6
National Dam Inspection Program - Big Brown Dam.
SUSQUEHANNA RIVER BASIN,
BROWNS RUN, CAMBRIA COUNTY

BIG BROWN DAM

(NDI I.D. NO: PA-00502,
DER I.D. NO: 11-1)
Number

PHASE I INSPECTION REPORT
NATIONAL DAM INSPECTION PROGRAM

PLATE 5

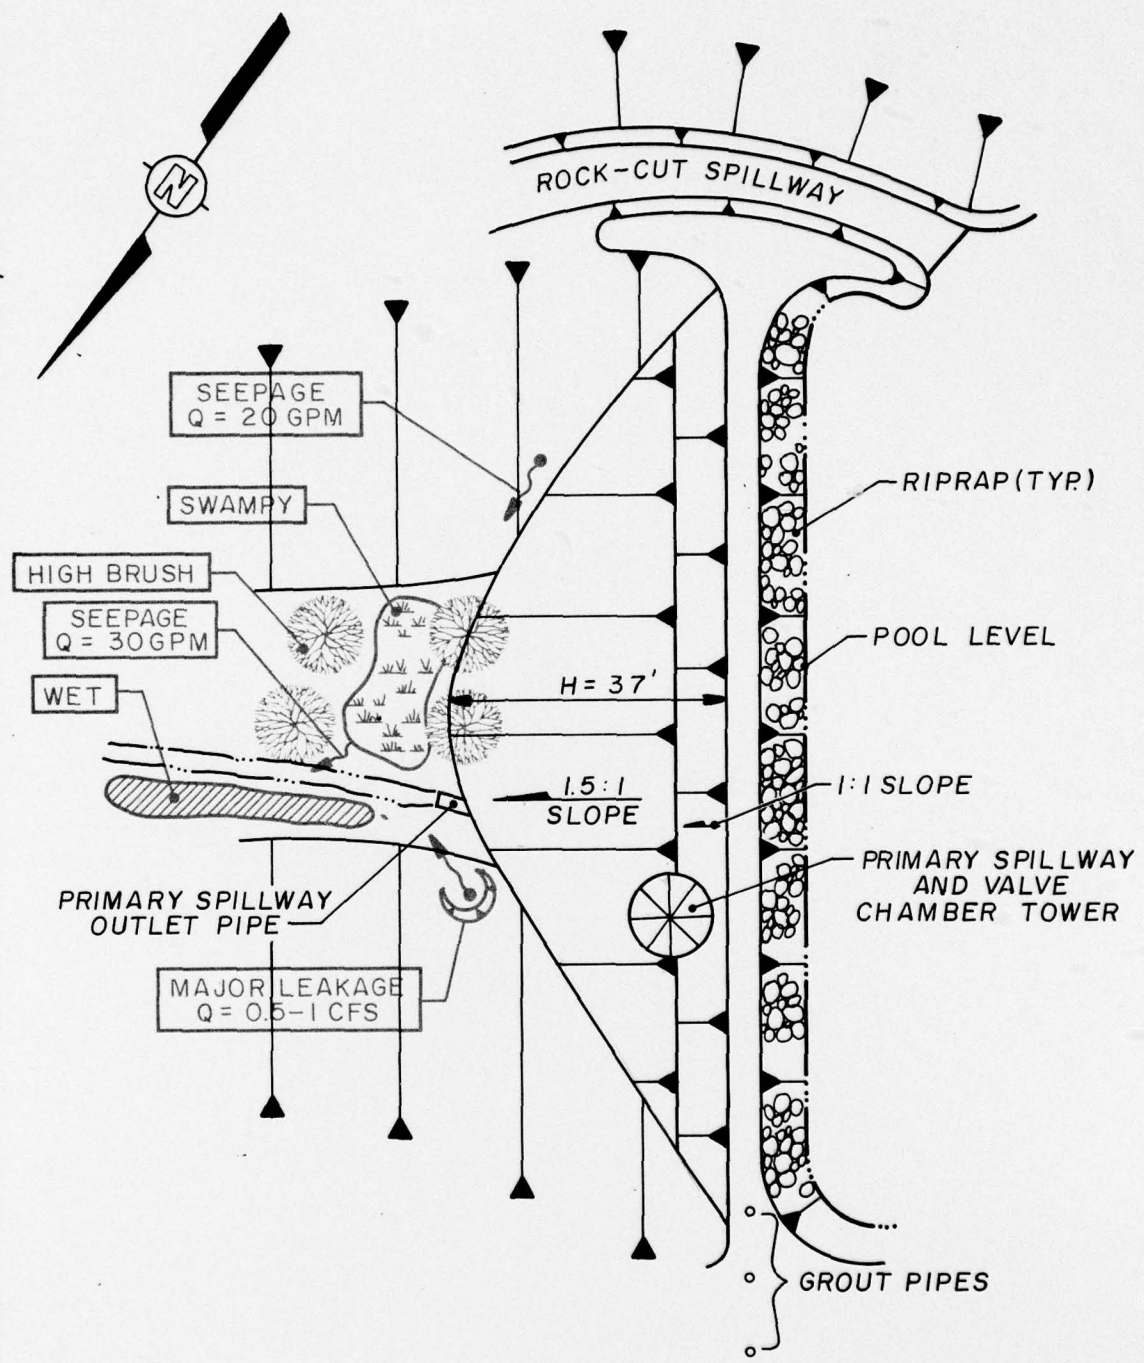
The specific observations are illustrated in Plate 5.

The most significant condition noted at the dam site was the presence of extensive swampy areas immediately below the toe of the dam. Ground in this area was found to be very soft. It appears that this swampy condition is caused by flow discharging into this area from the right abutment and underseepage. The flow from the right abutment seepage point was estimated to be on the order of 20 gallons per minute. This seepage point is located at the abutment/embankment interface about midheight of the dam. Flow from the swampy areas along the toe of the dam discharges into the primary spillway discharge channel through a small stream. Flow in this stream was estimated to be on the order of 30 gallons per minute. The flow at the major leakage point on the left abutment, which was reported to have existed since the completion of the dam, was estimated to be on the order of one-half to one cfs. Flow from the seepage points was found to be clear, showing no signs of internal erosion.

PLATE 6

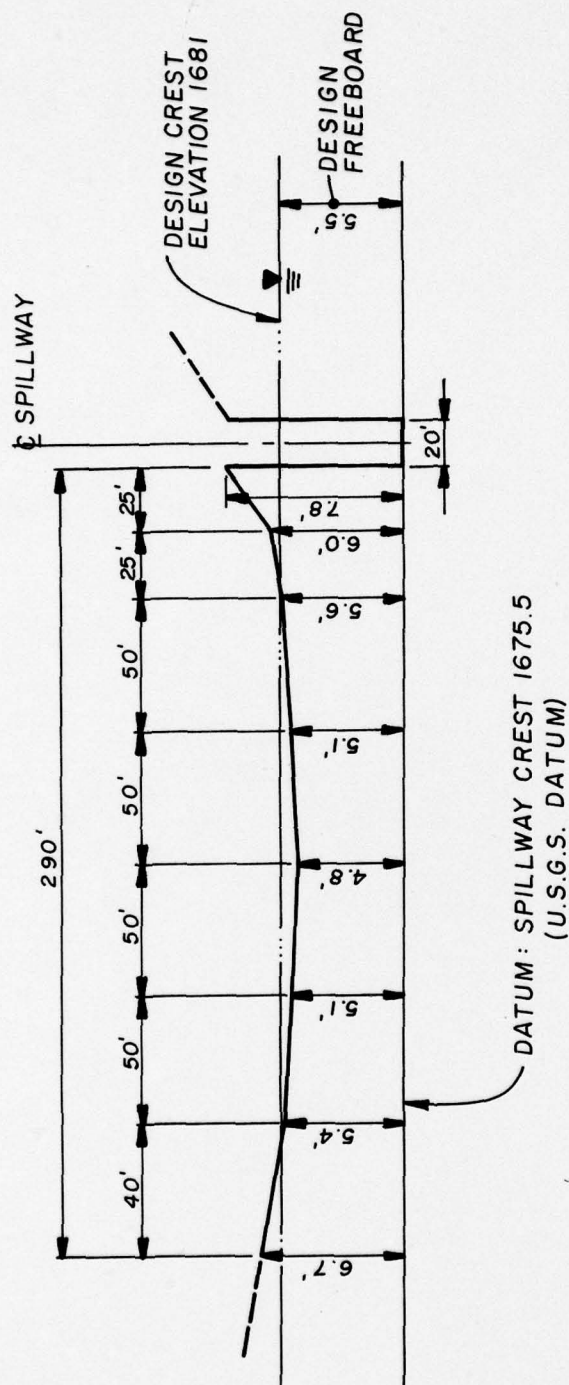
one vertical; on the remaining portions the slope was reasonably within the design slope of one and one-half horizontal to one vertical. The crest of the dam was surveyed relative to the emergency spillway crest elevation and was found to be generally below the design crest elevation. The crest profile of the dam is illustrated in Plate 6.

2. The structural and operational condition of the outlet facilities should be evaluated and necessary maintenance performed.
3. The crest of the embankment should be surveyed and low spots filled to design elevation.
